NAPA COUNTY REGIONAL PARK &
OPEN SPACE DISTRICT

May 9, 2022

As regards: The terminus of Conn Valley Road, parking, and the Hennessey Unit of Moore Creek Park

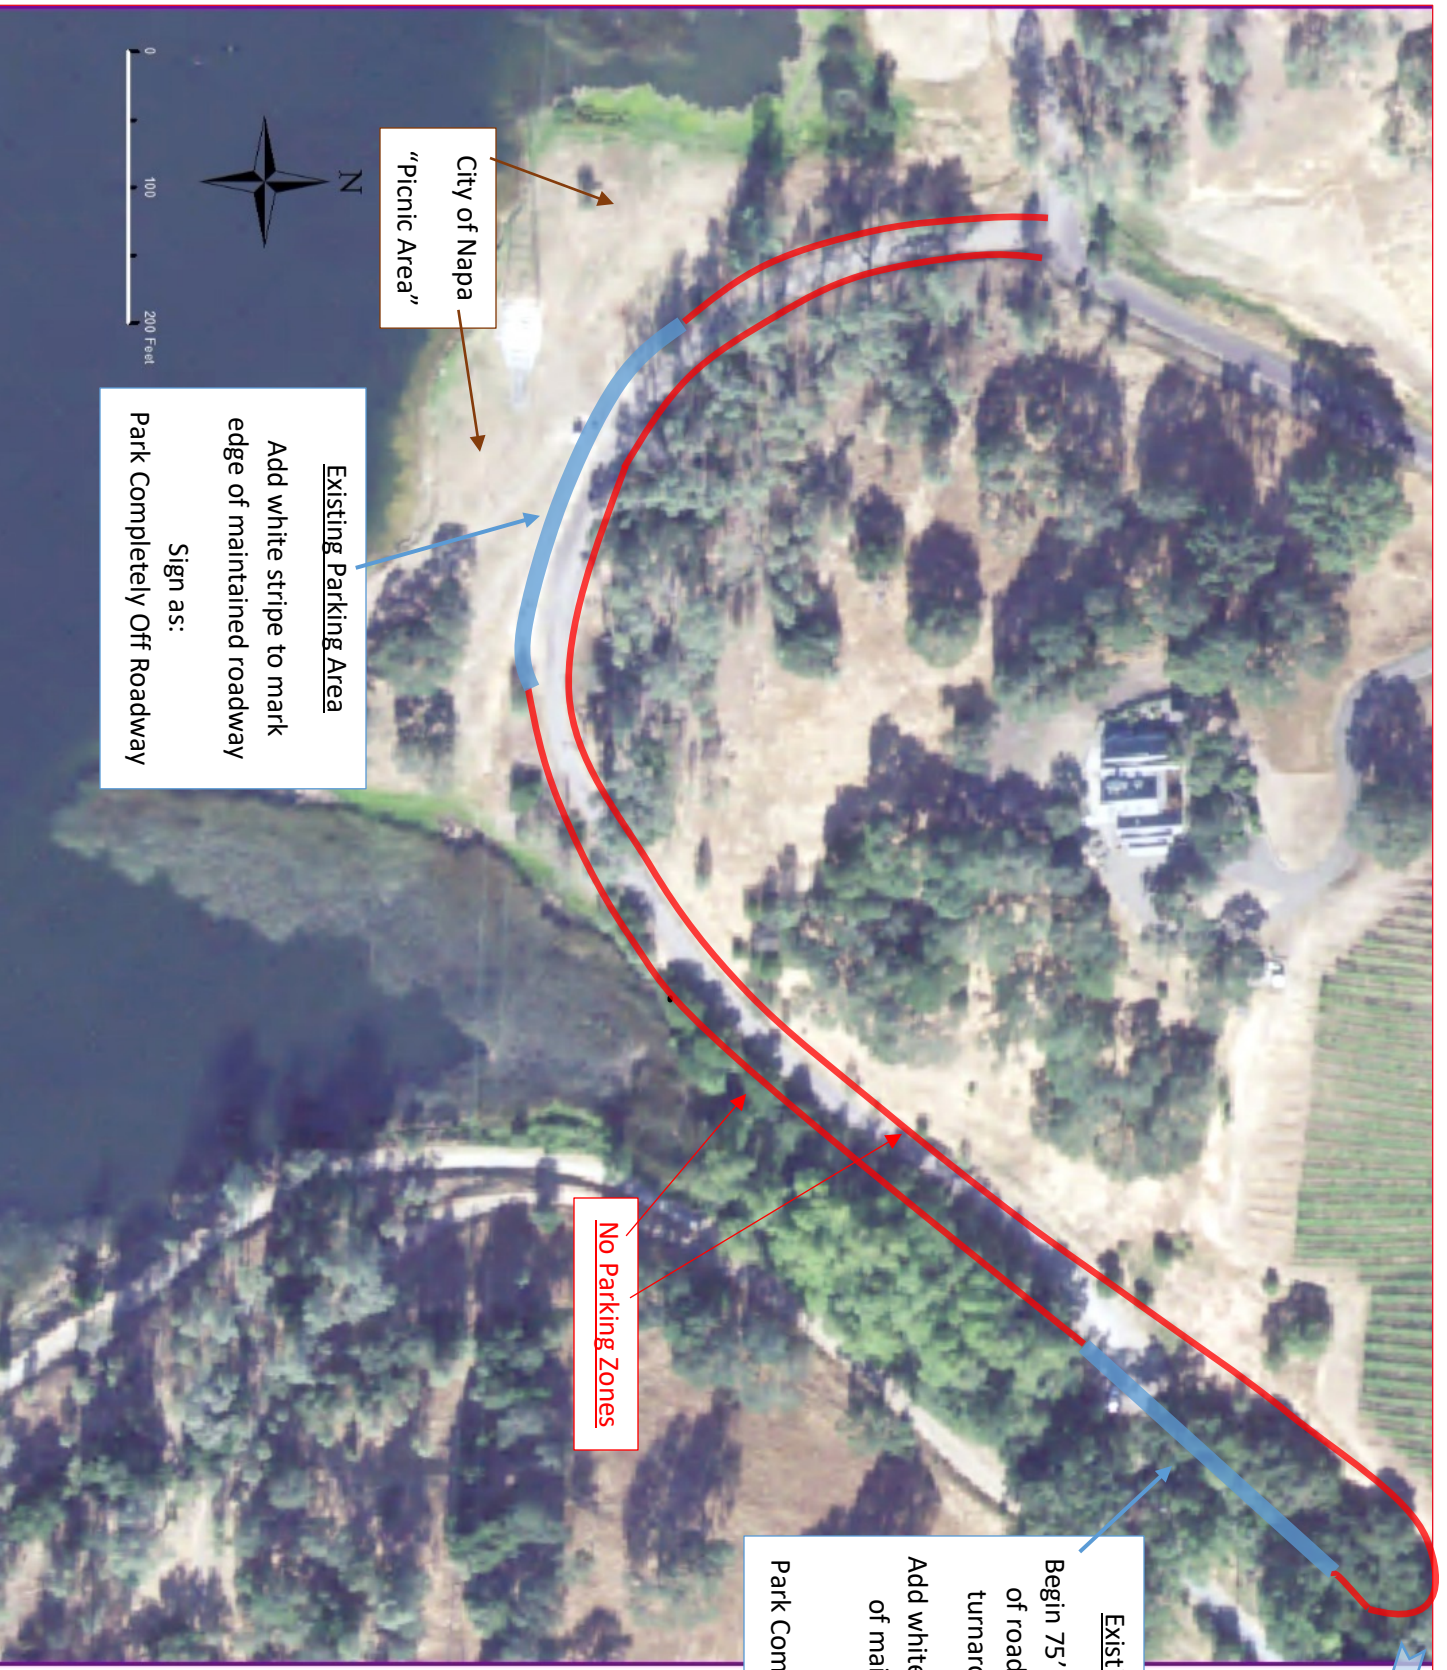
1. Extend the No Parking zone that now exists at the turnaround at the end along both sides of the road down well-past the City of Napa's "picnic area" (approximately 1,000' further to the east) excepting the two existing parking areas called out on the attached graphic.
2. Ensure that the No Parking zone at the terminus of Conn Valley Road is extended to at least 75' to improve large vehicle turnaround at the roadway dead end.
3. Paint a white line indicating the edge of the maintained roadway in the two existing parking areas, so that officers can more defensibly ticket people parked over that line in the maintained roadway in and adjacent to the existing parking areas.

4. Install signs at the existing parking areas saying something like “park entirely off roadway”.

City of Napa
"Picnic Area"

Existing Parking Area
Add white stripe to mark
edge of maintained roadway
Park Completely Off Roadway
Sign as:

No Parking Zones

Existing Parking Area
Begin 75' from mailbox at end
of road (to improve truck
turnaround at dead end)
Add white stripe to mark edge
of maintained roadway
Park Completely Off Roadway
Sign as:

M.C.P. Conn
Valley Access
Gate (approx..)
